To: Quinault Indian Nation
Karen Allston

From: Natural Systems Design, Inc.
Laura Zanetto, BLA, Wetland Ecologist
Torrey Luiting, MS, Professional Wetland Scientist (PWS #2734)

Date: April 29, 2022

Re: **Critical Review of the Chehalis River Basin Flood Damage Reduction Project
February 22, 2022, HDR Airport Levee Wetland Avoidance Technical Memorandum**

Figure 1. Wetlands Within and Near the Airport Levee Improvements Project Area

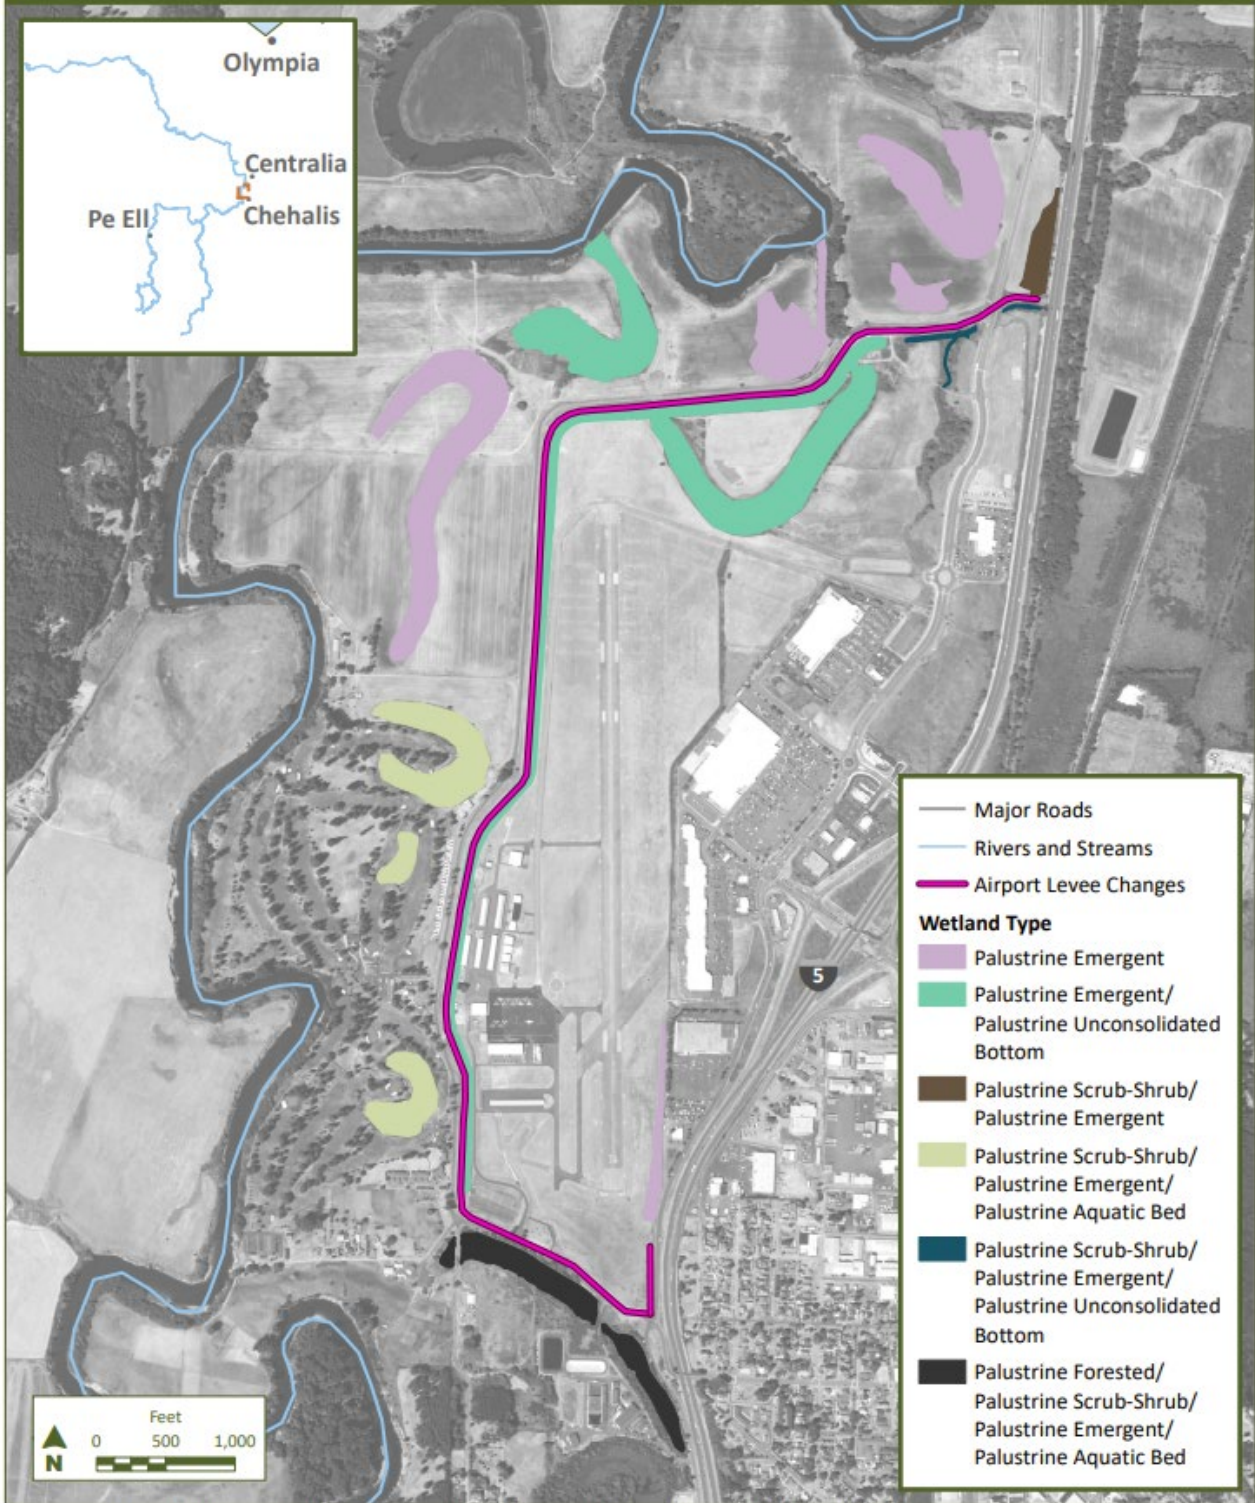
Quantification of wetland impacts in both the NEPA and the SEPA DEISs relied on a 2019 wetland delineation prepared by Anchor QEA, LLC for Ecology and the Corps (Anchor 2019). Figure 1, taken from the SEPA DEIS depicts wetlands as delineated by Anchor.

Preliminary, potential direct impacts to wetlands were disclosed in the draft NEPA and SEPA DEISs. The SEPA DEIS estimated 6.6 acres of direct, permanent impacts to Category II and III wetlands and 44.2 acres of direct, permanent impact to Category II and III wetland buffers (SEPA DEIS Appendix O, page O-ii). These wetland and wetland buffer impacts are specific to airport levee improvements and do not include additional impacts disclosed in the SEPA DEIS which are specific to construction of the FRE facility.

In contrast, the NEPA DEIS estimated 4.54 acres of direct, permanent impacts to Category II and III wetlands, and 16.61 acre of wetland buffer impact associated with widening the airport levee base (NEPA DEIS Appendix J, page 71). The 4.54 acres of impacts assumed that the linear drainage ditch present near the base of the levee, which was mapped as Wetlands C, D, and F (Anchor 2019) would be filled and relocated. These wetland and wetland buffer impacts are specific to airport levee improvements and do not include additional impacts disclosed in the NEPA DEIS which are specific to construction of the FRE facility.

Figure 2. Location of Raised Road Improvement
 Image Source: Clip of NEPA DEIS Figure 3.6-3

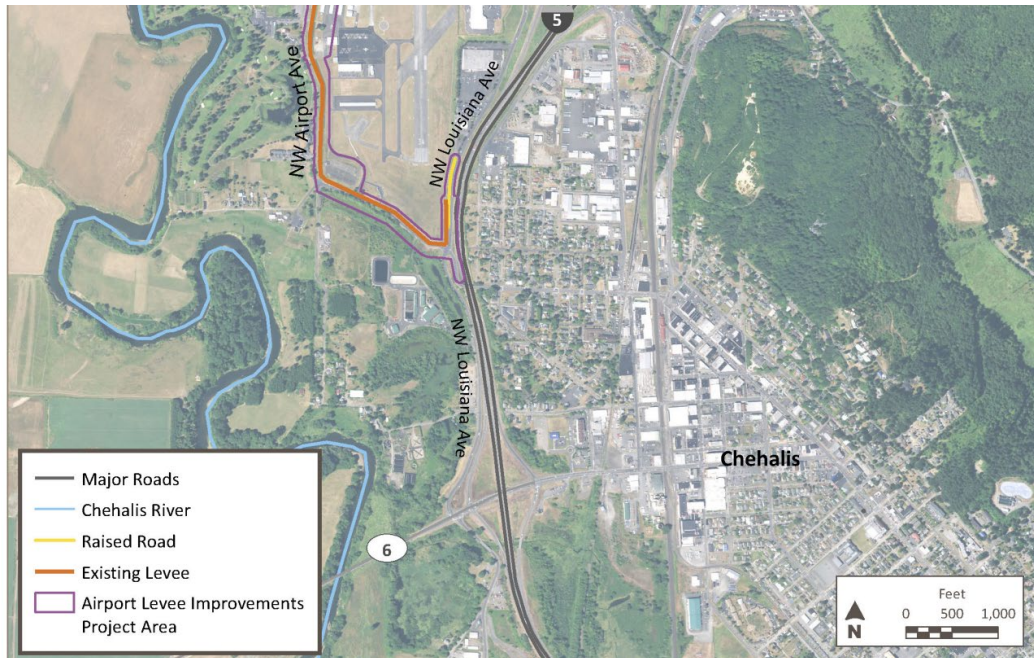
Both DEISs present “raising 810 feet of NW Louisiana Avenue along the southern extent of the airport to a height equal to the raised levee height to protect against flooding” (NEPA DEIS, page 33; SEPA DEIS, page 22) as a component of the proposed levee project. Although the Technical Memo notes that “the [FCZD] proposes to... raise the elevation of a section of connected road embankment (NW Airport Road) as part of the [project]” (Technical Memo, p. 1), it does not evaluate this element of the proposed project. Aside from this mention, the Technical Memo is altogether silent on the proposed construction methods for completing this portion of the proposed levee project.

It is unclear in all documents where exactly the 810-foot segment of road slated for raising is situated, however the most detail on location of road raising is provided in NEPA DEIS Figure 3.6-3, a clip of which is included herein as Figure 2. The 2019 Delineation (Figure 3) documented a large wetland, Wetland H, at the northern terminus of the delineation study area, along a portion of NW Louisiana Avenue. The Technical Memo fails to characterize this element of the proposed project and has therefore omitted critical evaluation of potential impacts to Wetland H and its buffer. Without this characterization, it is impossible for decision makers to evaluate whether the alternative construction methods evaluated would avoid wetland impacts related to raising the NW Louisiana Avenue component of the proposed levee project.

5. Disclosure of appropriate detail to determine the location, extent, and scope of the “810-foot road modifications” for evaluation of potential direct, indirect, and cumulative impacts to wetlands.

Figure 4. Wetland and Tributary Connections to Wetlands C and D

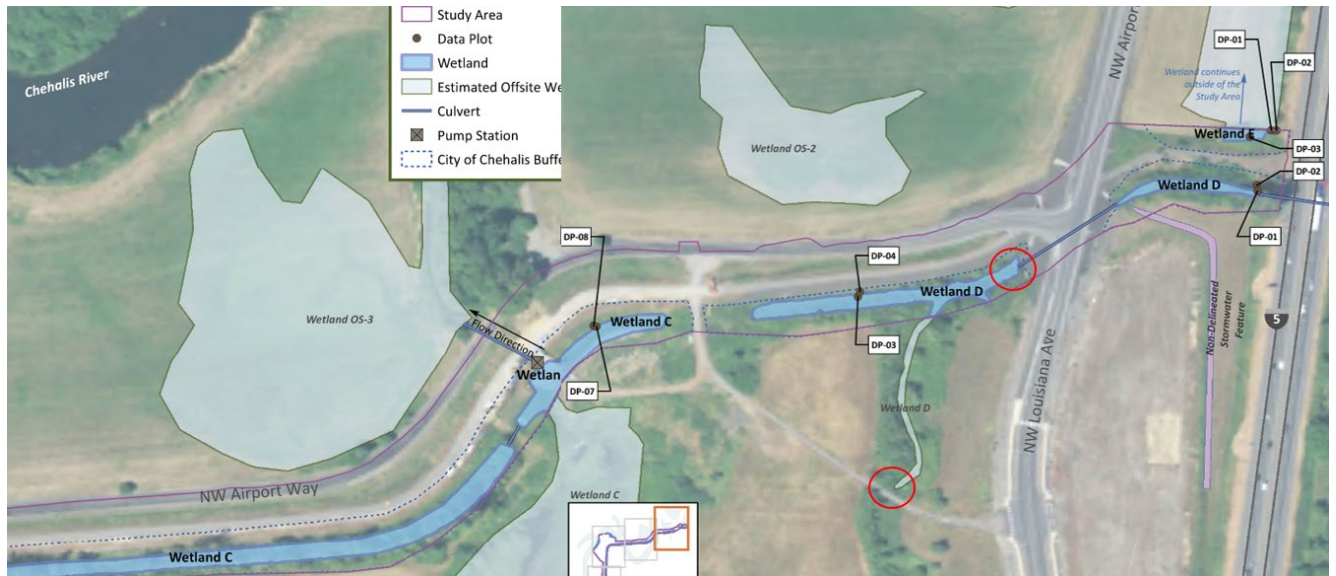
Additionally, the 2019 Delineation Report, both DEISs, and the Technical Memo fail to consider the potential for direct or indirect impacts to Wetlands C and D which are associated with at least three culverts which convey tributary flow to the Chehalis River (Figure 4; 2019 Delineation Report). Wetland C appears to have a direct hydraulic connection to “offsite Wetland OS-3” (Anchor 2019) and the Chehalis River tributary visible in Figure 4, however these hydraulic and hydrologic connections and potential impacts from construction of the proposed levee project are not discussed. According to two WFDW fish passage inventory reports that assessed two culverts located along Wetland D (indicated by red circles in Figure 4), the portion of Wetland D outside of the levee delineation study area is overflow from Salzer Creek (a tributary of the Chehalis River) or Airport Lake (Schotman and Young 2019; Arams and Schotman 2019) which is appears to be illustrated in the 2019 delineation as Wetland C (Figure 4). The Technical Memo fails to consider the direct, indirect, or cumulative impacts to fish and wildlife and/or habitat functions associated with modifications to the levee, this drainage, or these culverts.

3. Evaluation of temporary, indirect, and cumulative impacts to wetland and wetland buffer area and function relative to the proposed actions.
4. Additional detail on existing infrastructure including the state of existing levee structures, culverts, pumps, and associated infrastructure, and their ability to accommodate the proposed changes.
